ADDENDUM

PROJECT:	La Vista City Centre South MU – Lot 15	**PROJECT NO.:**	F16132
TO:	Prospective Bidders	**DATE:**	05/04/2017
FROM:	BVH Architecture	**ADDENDUM NO.:**	#2

1 SECOND FLOOR - SPECIAL SYSTEMS

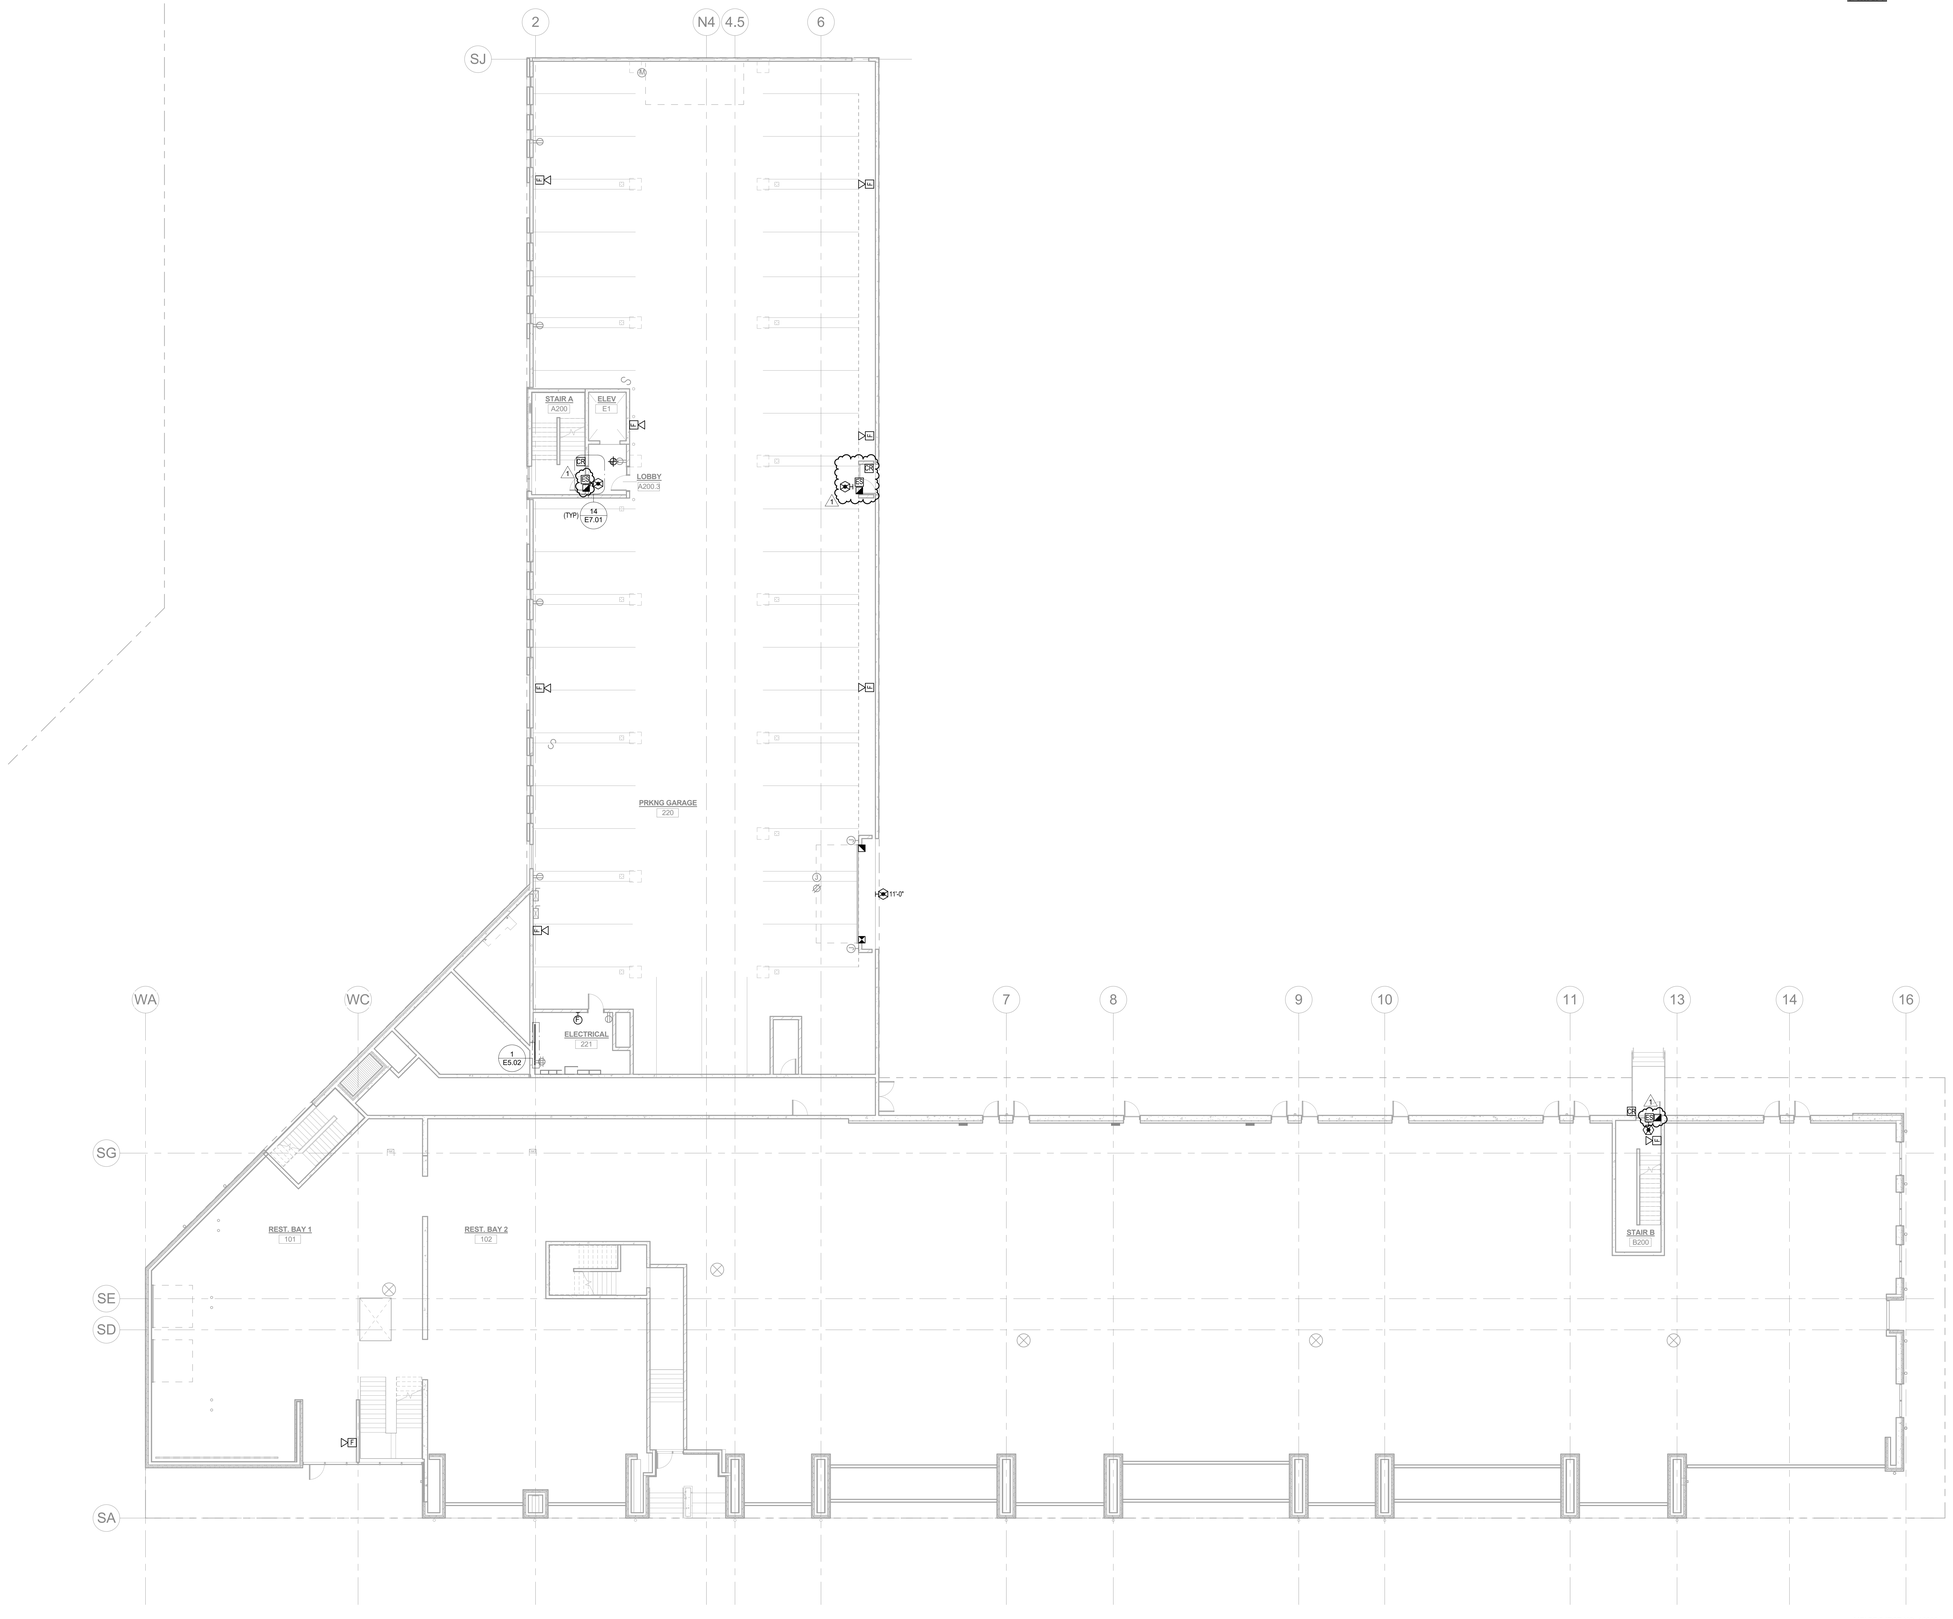
3. Sheet E3.02 – Second Floor – Special Systems
    a. Door A200 – Revise power transfer hinge to electric strike.
    b. Door 220.1 – Add card access rough-ins.
    c. Door B200 – Revise power transfer hinge to electric strike.

1 THIRD FLOOR - SPECIAL SYSTEMS

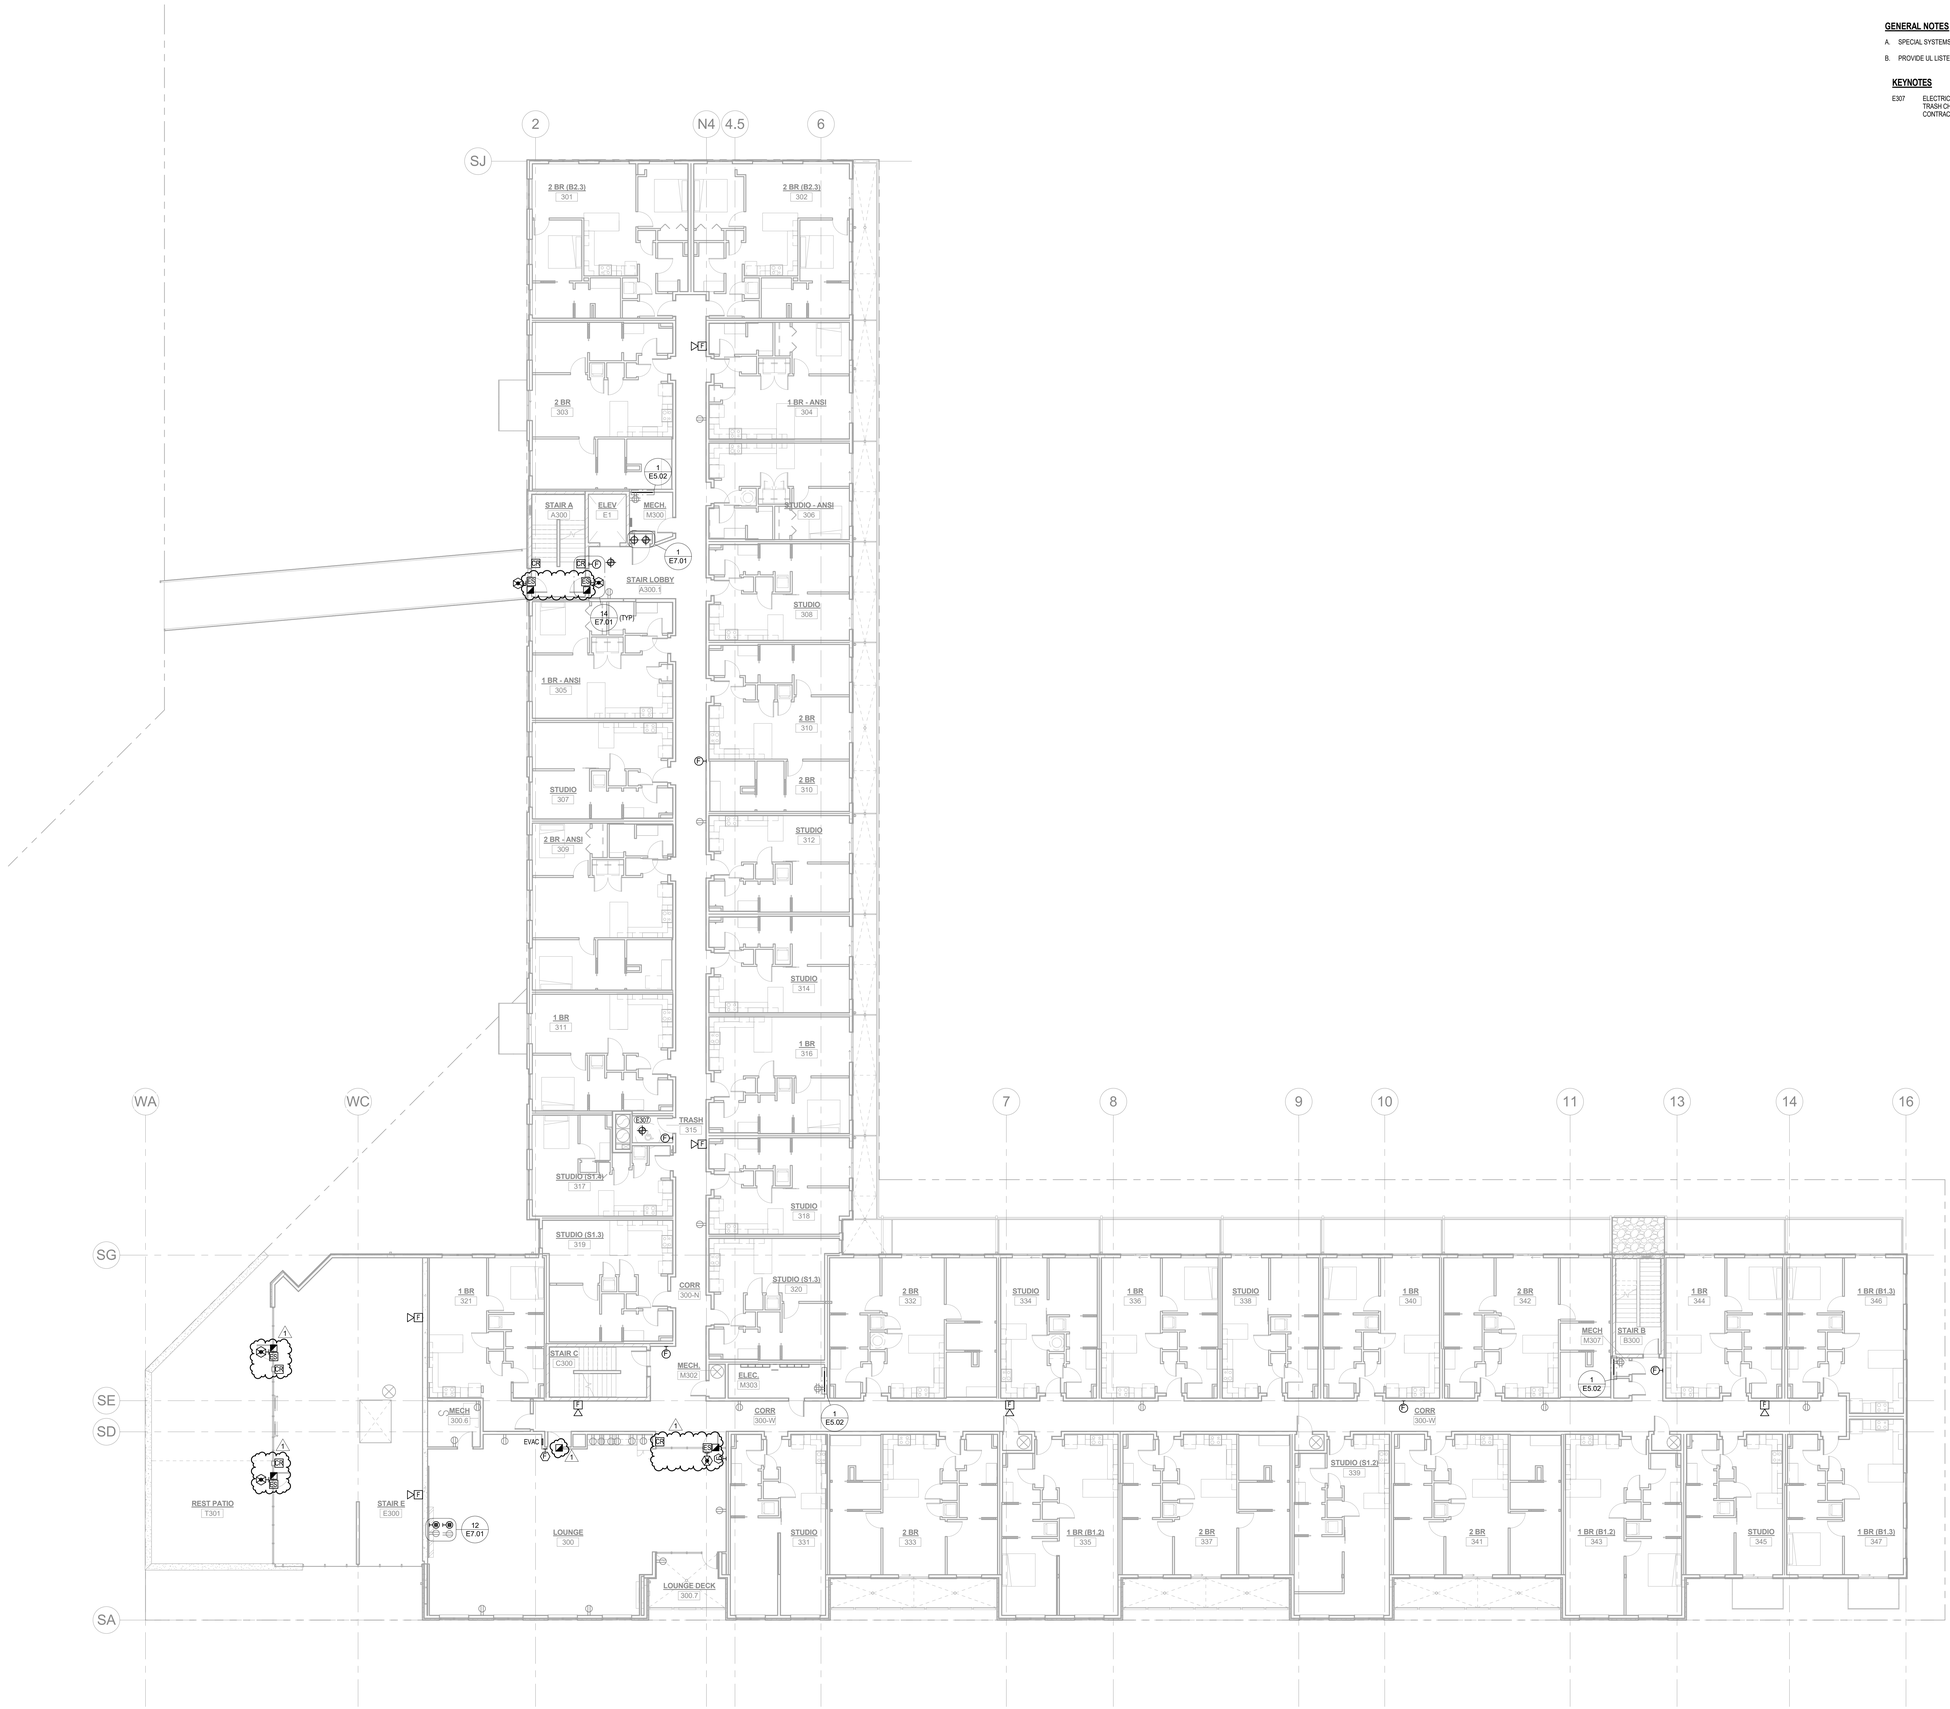
4. Sheet E3.03 – Third Floor – Special Systems
    a. Door A300.1 – Revise power transfer hinge to electric strike.
    b. Door A300.2 – Revise power transfer hinge to electric strike.
    c. Door 300.1 – Add card access rough-ins.
    d. Door 300.2 – Add door contact rough-in.
    e. Door E302A.1 – Add card access rough-ins.
    f. Door E302A.3 – Add card access rough-ins.

1 FOURTH FLOOR - SPECIAL SYSTEMS

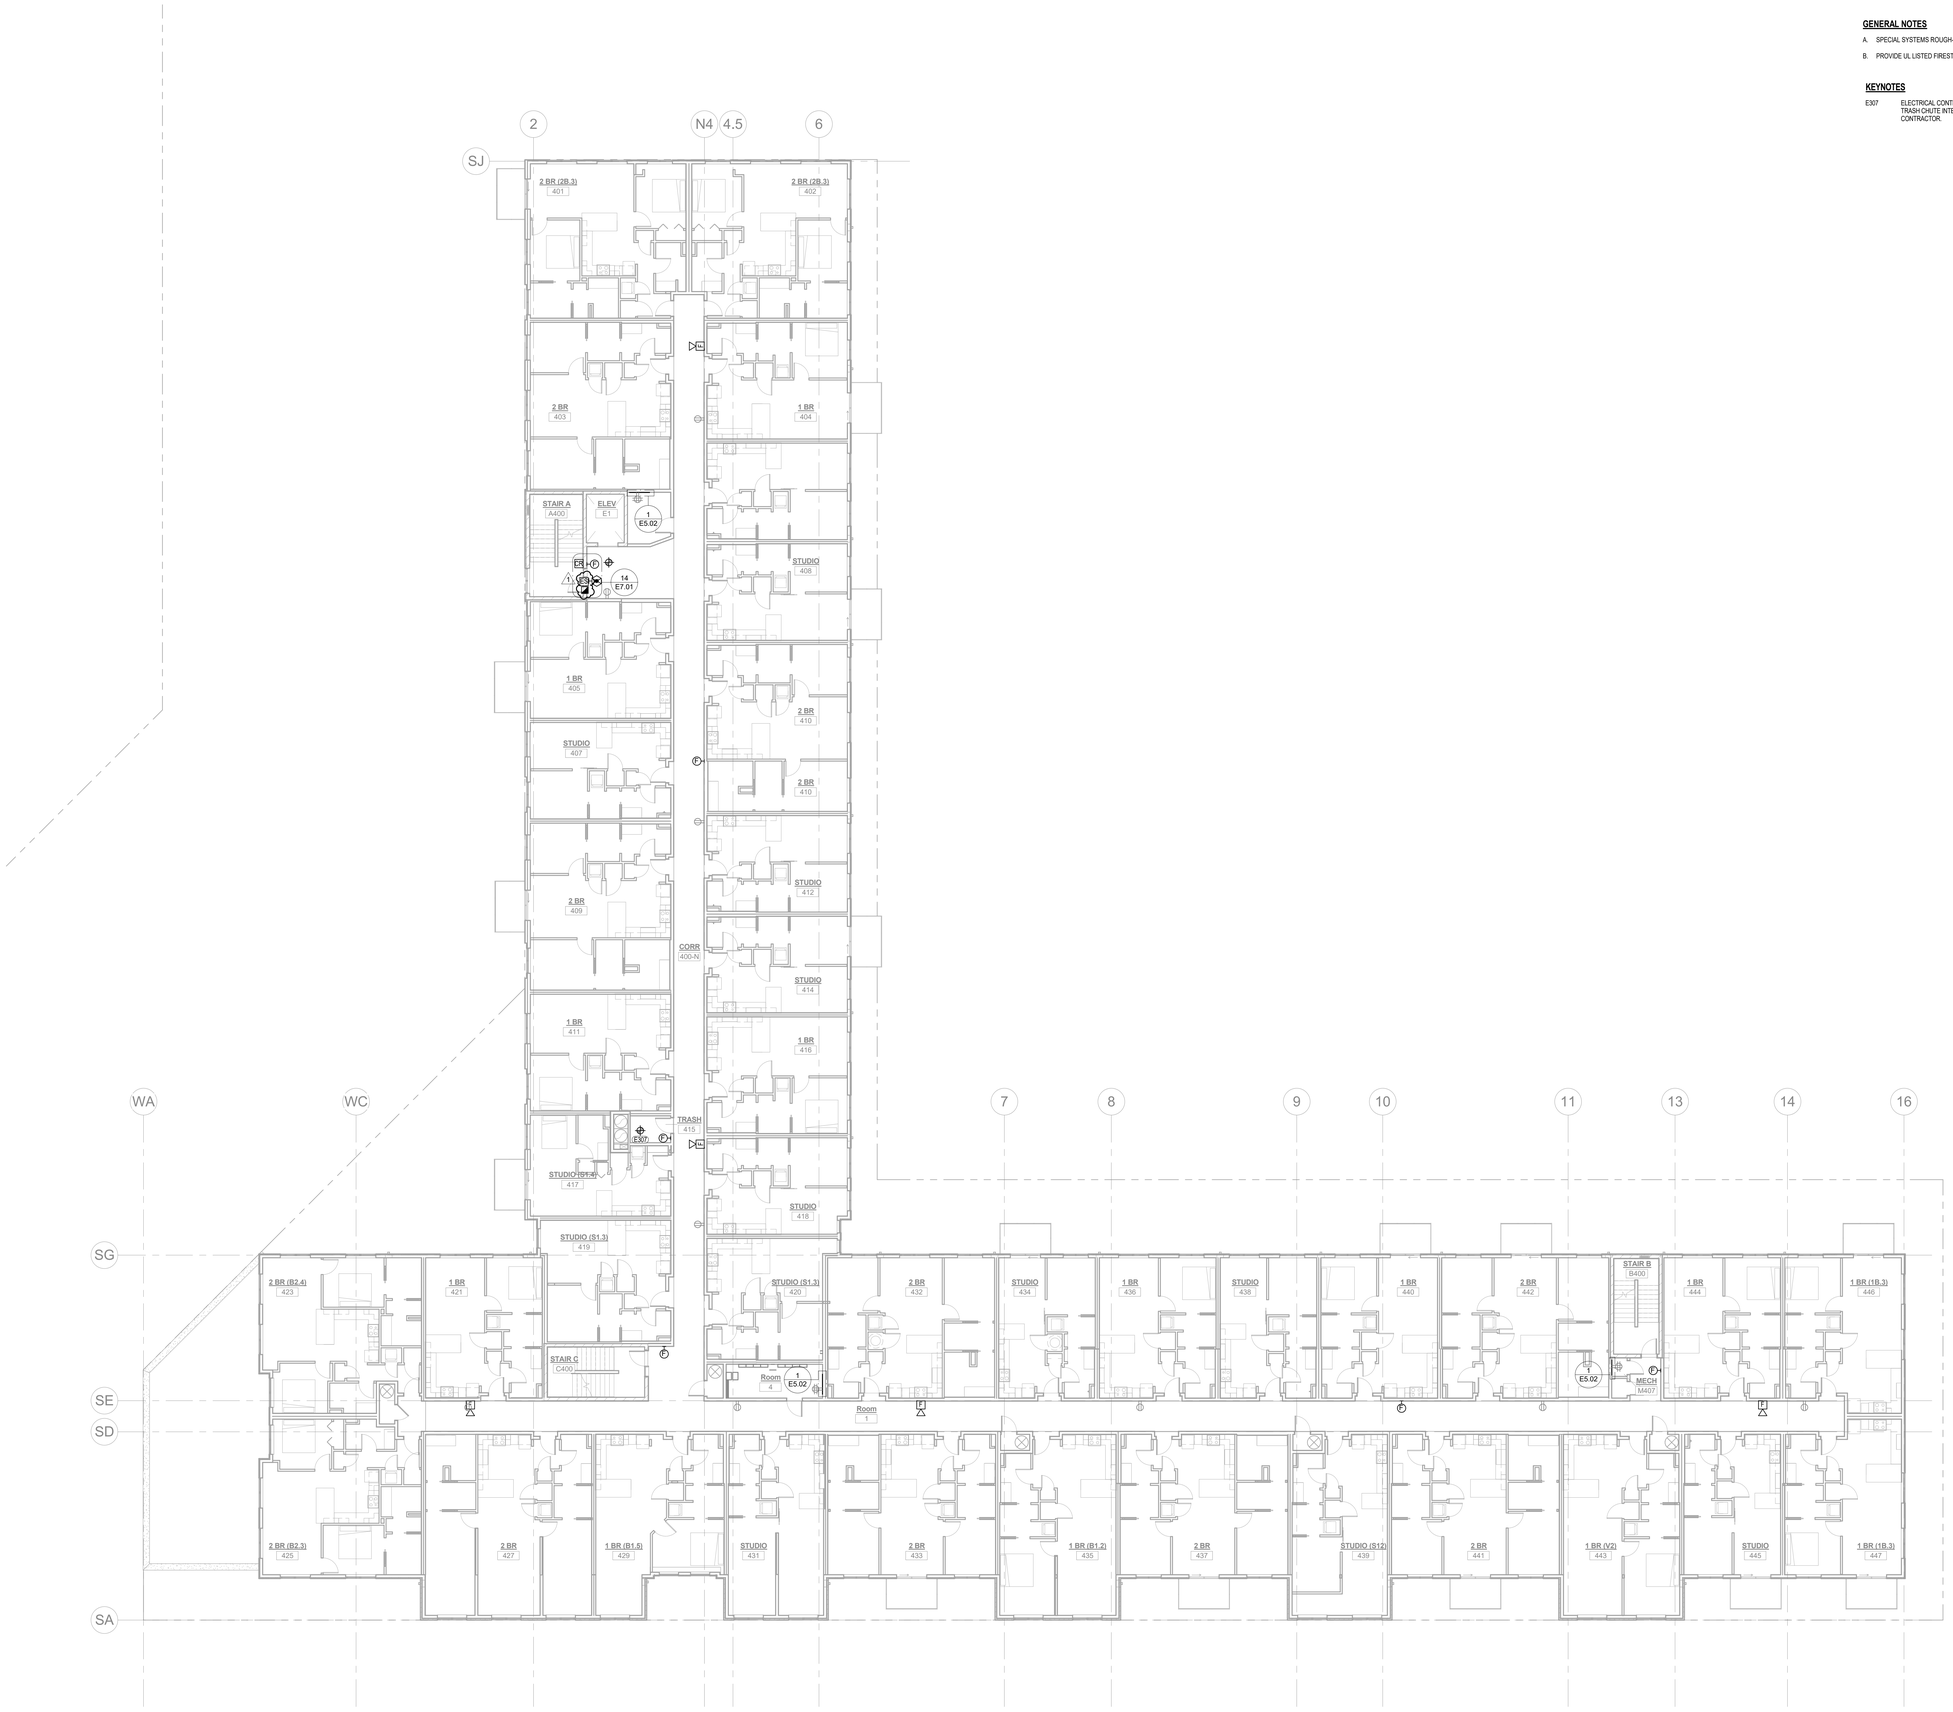
5. Sheet E3.04 – Fourth Floor – Special Systems
    a. Door A400 – Revise power transfer hinge to electric strike.
